Date: May 15, 2002

TO: Board Members - Parks and Recreation
FROM: General Manager - Parks and Recreation
**SUBJECT: Vancouver Convention and Exhibition Centre Site:
Rezoning and Street Closures**

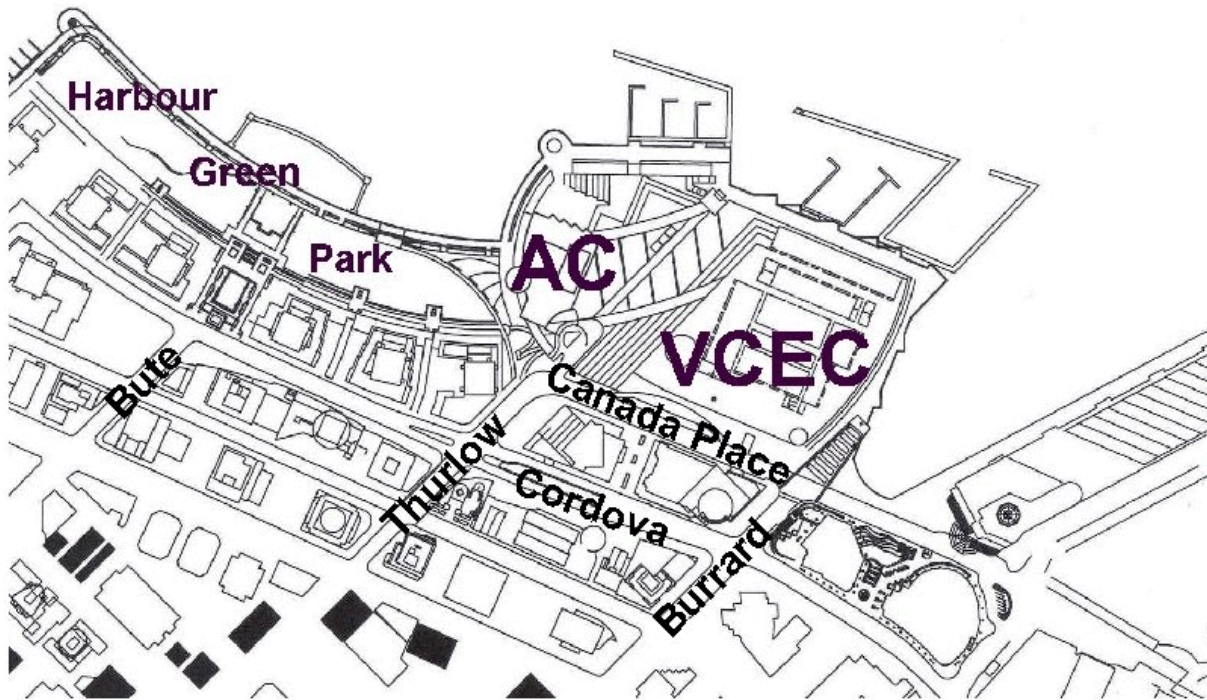
Burrard Landing is located at the foot of Burrard Street between Harbour Green Park and Canada Place (see site plan). The site is regulated by the Coal Harbour Official Development Plan and

Parallel to the Council Report on the rezoning, Council is receiving a report on changes in road configuration involving the north ends of Thurlow and Burrard Streets, and a western extension of Canada Place (the road). As part of these road changes, a small triangle of land (185.5 square meters or 0.05 acres) that was intended to eventually become part of Harbour Green Park will now become part of the straightened Thurlow Street road allowance.
